March 16, 2023

RE: Status of ANX 23-02, SUB 23-01, & Z[M]C 23-02 "E. Lincoln Road" along the north side of E. Lincoln Rd east of 1651 E. Lincoln Rd (Tax Lot 051W17AB00602; Partition Plat 1995-067 Lot 3)

Staff reviewed the degree of completion of the Annexation (ANX), Preliminary Subdivision (SUB), and Zone Map Change (Z[M]C) consolidated application package for the subject property submitted February 14, 2023 and determined it incomplete as of March 16, 2023.

**1625 E Lincoln Street 26 Townhouse lots Subdivision**  
**[Tax Lot 051W17AB00602](#)**  
**ANX 23-02**  
**Public Works Comments**  
**(For Civil Plans Dated 02-02-23)**  
**March 15, 2023**

WDO Figure 3.01A

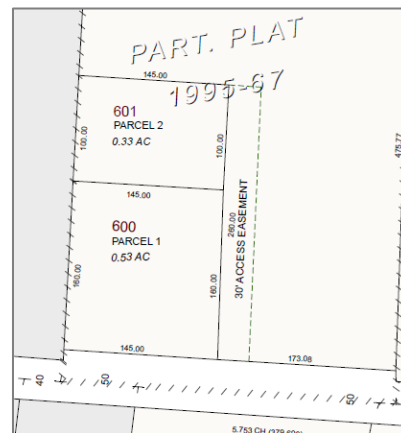
**E. Street improvements:** Per WDO Figure 3.01A, “Boundary Street”, Lincoln frontage improvements are required also along 1651 E. Lincoln Rd. The site plans and Tax Map 051W17AB indicate that the depth of that property is exactly 260 ft.

Revise to extend west E. Lincoln Road half-street improvements, and revise the subdivision narrative p. 7 where it addresses WDO 3.01.03D. Staff knows at this time that the half-street ROW fronting Tax Lot 051W17AB00600 is 30 ft – 6 ft short of 36 ft per WDO Figure 3.01D “Service Collector”. Address also how the applicant/developer would dedicate 6 ft of ROW.

SHEET NUMBER  
**P2.1**  
 CITY OF WOODBURN FILE X

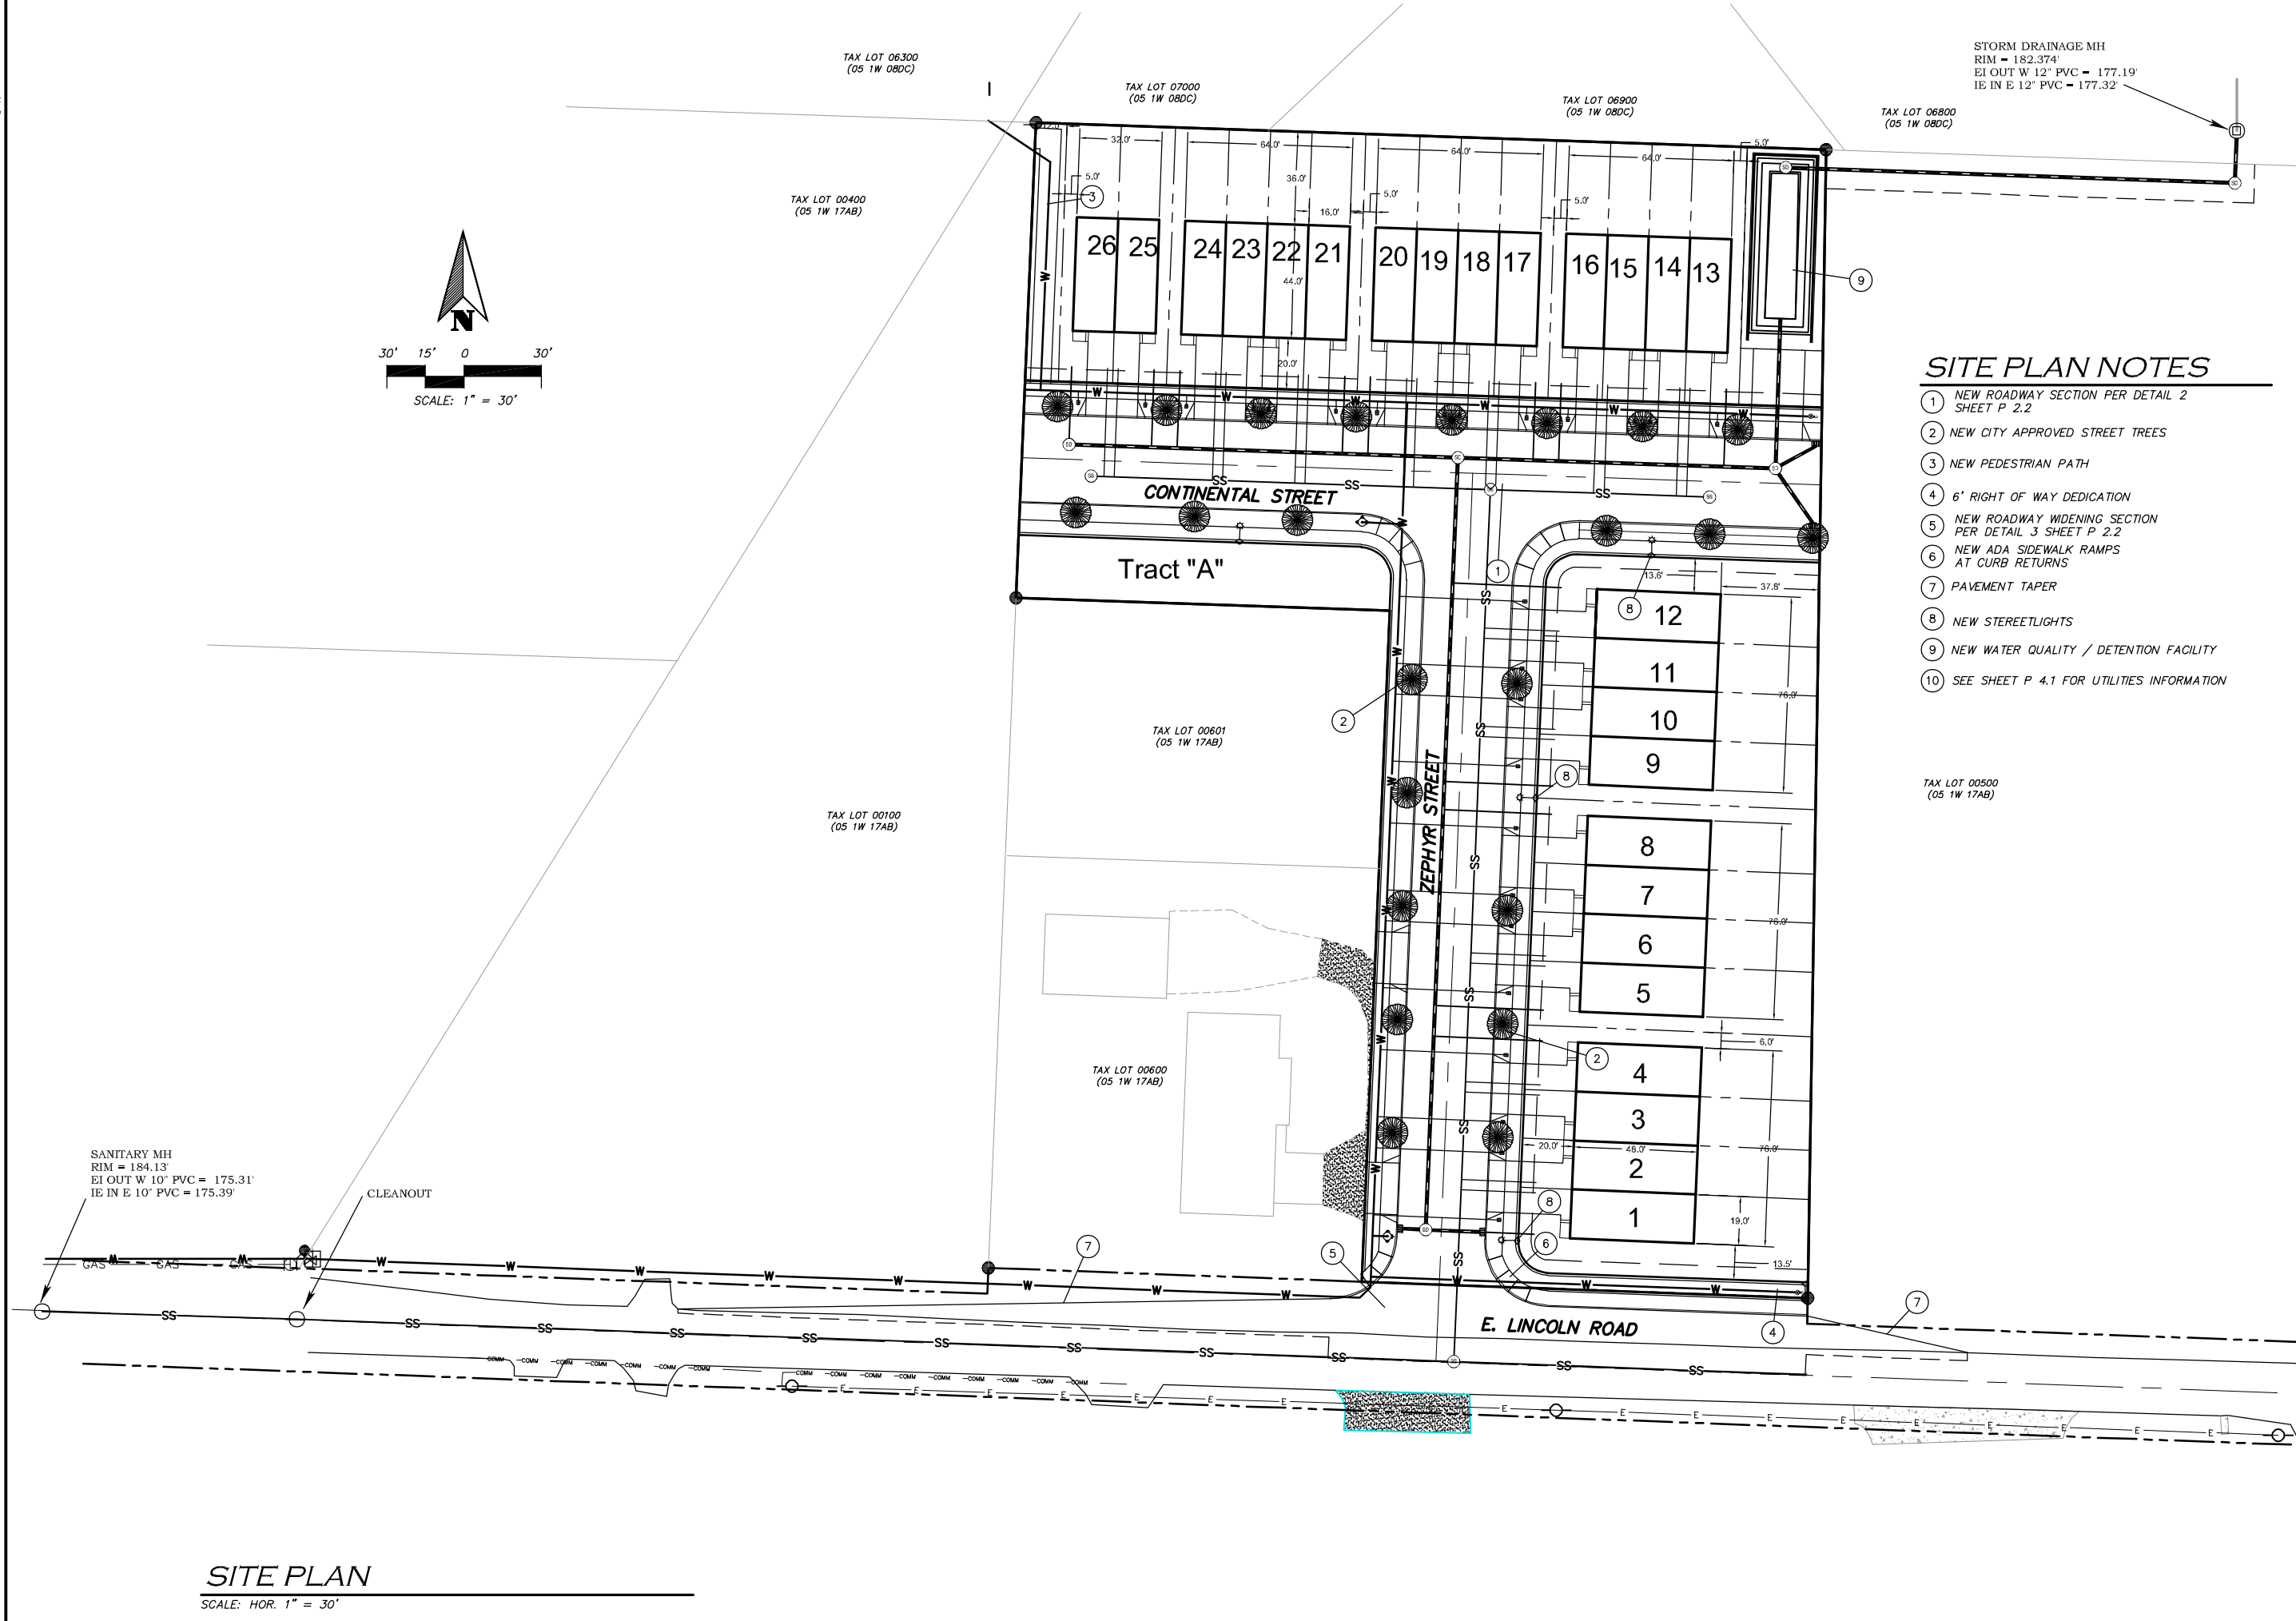
1. Provide preliminary storm drainage system for Lincoln Street.
2. Indicated on the plans that the proposed storm drainage detention facility and storm lines from the detention facility to proposed or existing public storm mains are private systems maintained in perpetuity by the Developer/owner or homeowner's association. A private easement is required for the private line between the detention facility and existing public line located in the Kalugin's Subdivision, a copy of the recorded private easement shall be provided to the City prior to the civil plan's approval.

3. Provide preliminary street lighting plan for E Lincoln Street. For information street lighting is required for all existing streets and proposed streets. Applicant to provide street lighting in accordance with street lighting plan approved by the City and Marion County and conforming to Portland General Electric installation and plan under option B.

4. Show easement lines for future water main located on private property, water main on adjacent westerly property (1625 E Lincoln Street). All City-maintained facilities located on private property shall require a minimum of 16-foot-wide utility easement conveyed to the City by the property owner. This is the applicant's responsibility to provide, not the City's. Utilities of unusual depth, size or location may require a larger width.

5. Clearly show a watermain loop system for this development. Provide a preliminary design for the future water main connection in the northwest corner of this development to existing water main located in adjacent property. The preliminary design shall include the existing water main, new water main alignment with public utility easements, hot tap connection, etc.

6. Extend the proposed sewer main in Continental Street to the easterly property limits of proposed Street.
7. All proposed driveways by street intersections shall meet requirements for sight distances as per national and state guidelines. Driveway location shall be

8. Applicant to comply with Woodburn Development Ordinance and Fire District requirements for dead end street.
9. Fire hydrants locations and fire protection requirements shall be as per the Woodburn Fire Districts and City of Woodburn requirements.
10. For information fire hydrants are used for all dead-end water mains instead of blowoffs. Actual fire hydrant locations and in-line valving locations shall not be determined until the construction final plan review.
11. For information all public sanitary sewer and stormwater lines dead end with manholes.
